Alabama Power

Docket Nos. 50-348
50-364

TEMPORARY CHANGE TO OPERATING LICENSE
NO. NPF-2 AND NPF-8 TECHNICAL SPECIFICATIONS

Figure 1 - Modification to Farley Nuclear Plant
Service Water Recirculation System

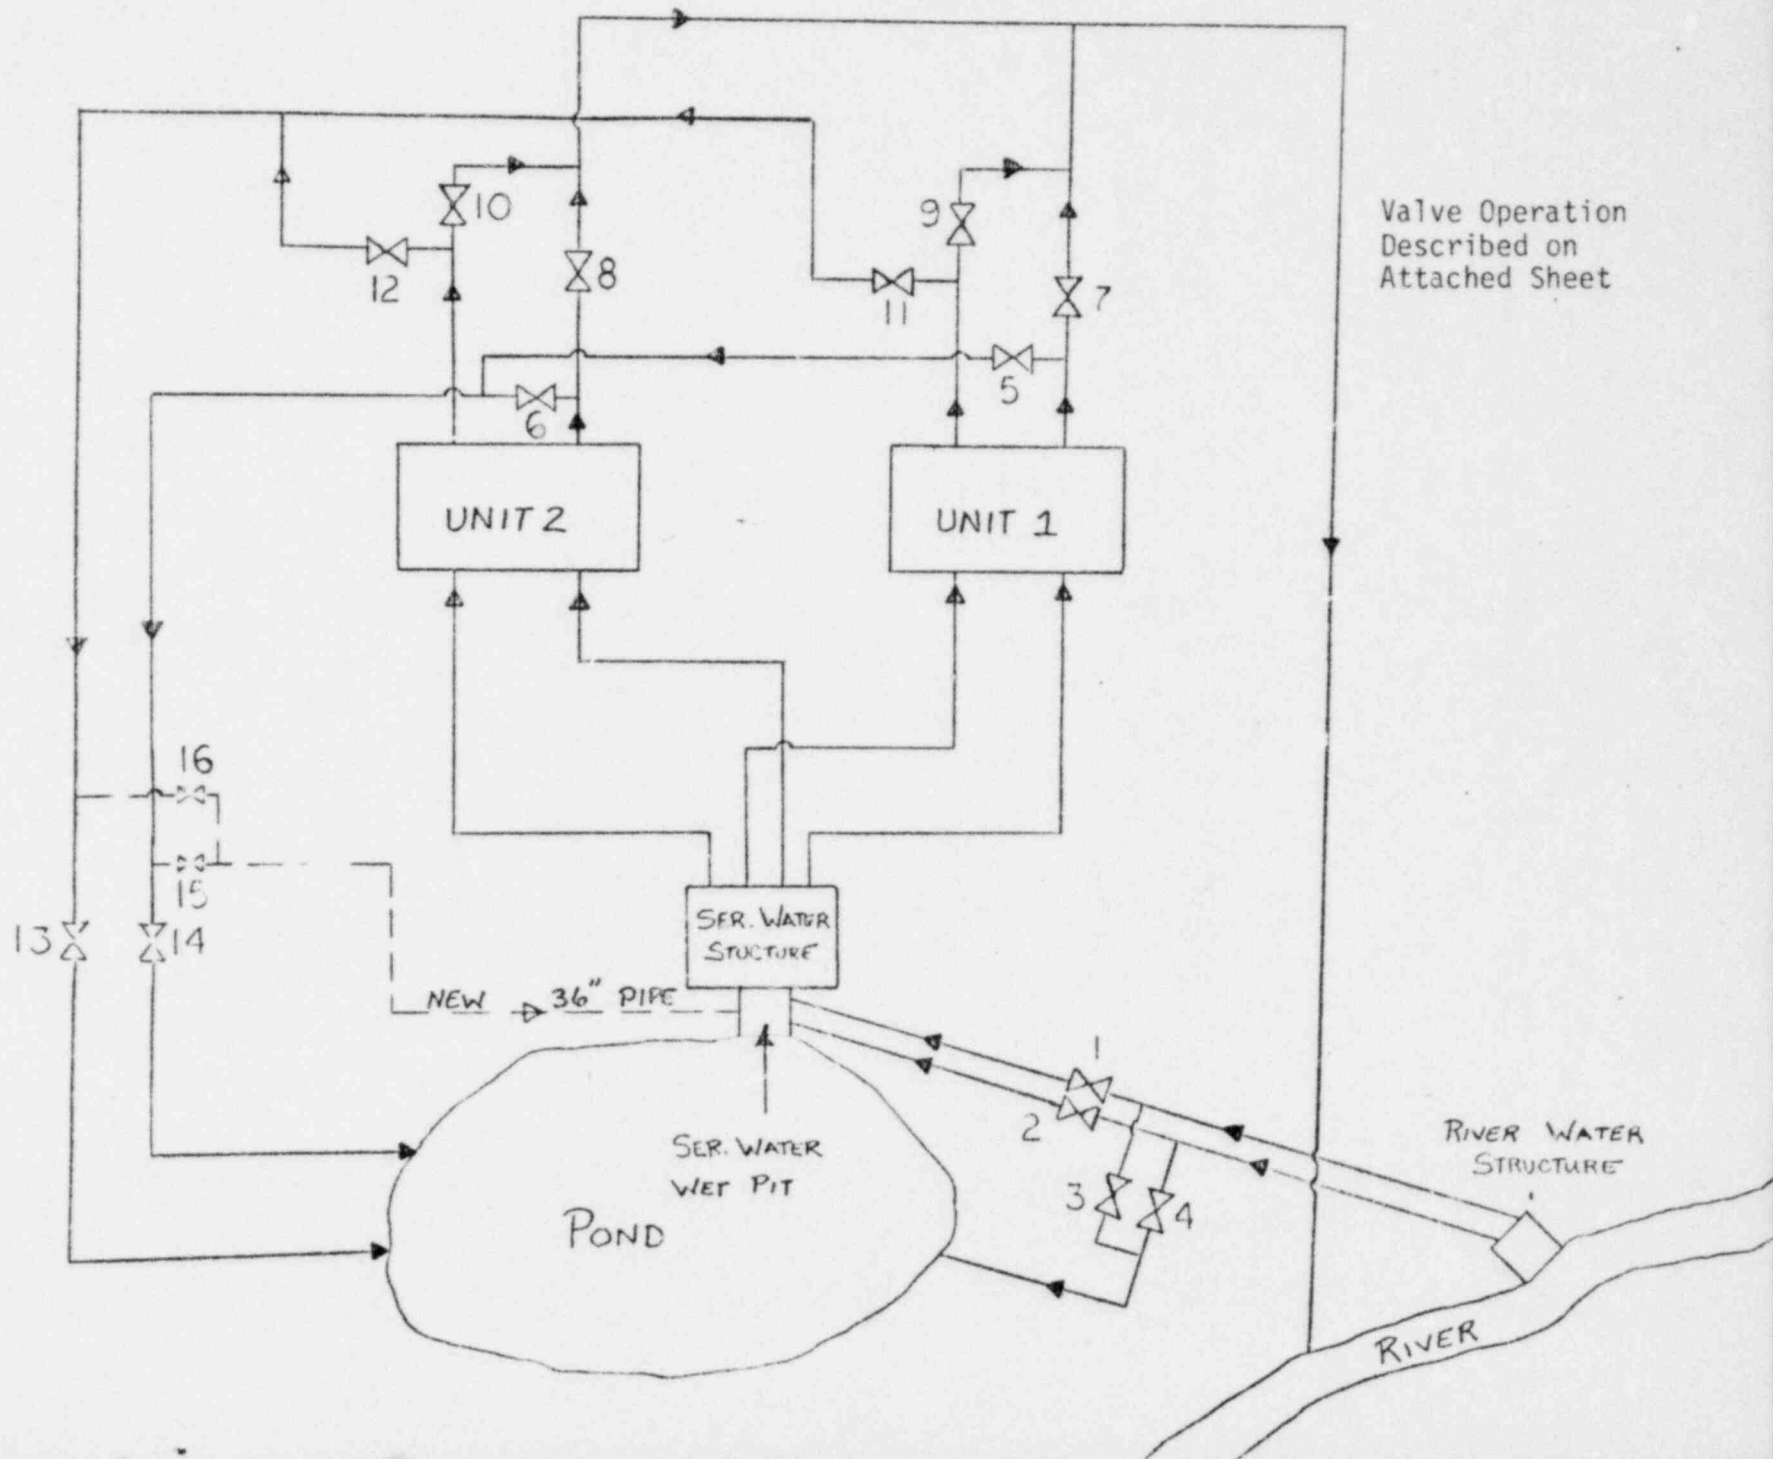
In order to restore the time available for operator action, Alabama Power Company will make available an additional source of water to the service water pumps under these conditions. This will be accomplished by the addition of a safety grade 36" line running from the two existing 60" service water recirculation lines (service water return to pond) directly into the service water wet pit. (See Figure 1 for schematic of line addition.) Under the accident conditions described in FSAR Section 9.2.1.3, recirculation of service water directly to the service water structure wet pit via the two 60" return lines and the new 36" line would be automatically initiated. This modification will ensure a period of time substantially in excess of 30 minutes before operation action would be required to balance

During normal operation, river water valves 1 and 2 are closed and normal flow is to the pond through valves 3 and 4. Service water is supplied to the plant and discharged to the river through valves 7 and 9 for Unit 1 and valves 8 and 10 for Unit 2. The pond recirculation valves 5 and 11 for Unit 1 and valves 6 and 12 for Unit 2 are closed. The proposed valves 13 and 14 are opened and valves 15 and 16 are closed.

When this scenario occurs, the service water flow out of the wet pit exceeds the river water make-up to the wet pit. The stoplogs in the service water wet pit are at elevation 180'-0". Upon reaching 179'-6", train "A" and train "B" level switches will open the valves 5, 6, 11, 12, 15 and 16 and valves 7, 8, 9 and 10 will close. Valves 13 and 14 will close to a throttled position such that a portion of the flow will be diverted to the service water wet pit and a portion to the pond.

NOTE: The system is designed such that one train of recirculation flow will provide the necessary flow to the service water wet pit to extend the operator action time to greater than 30 minutes. At this time the operator will take action to balance service water requirements with the river water flows and restore the service water valves to the normal configuration.
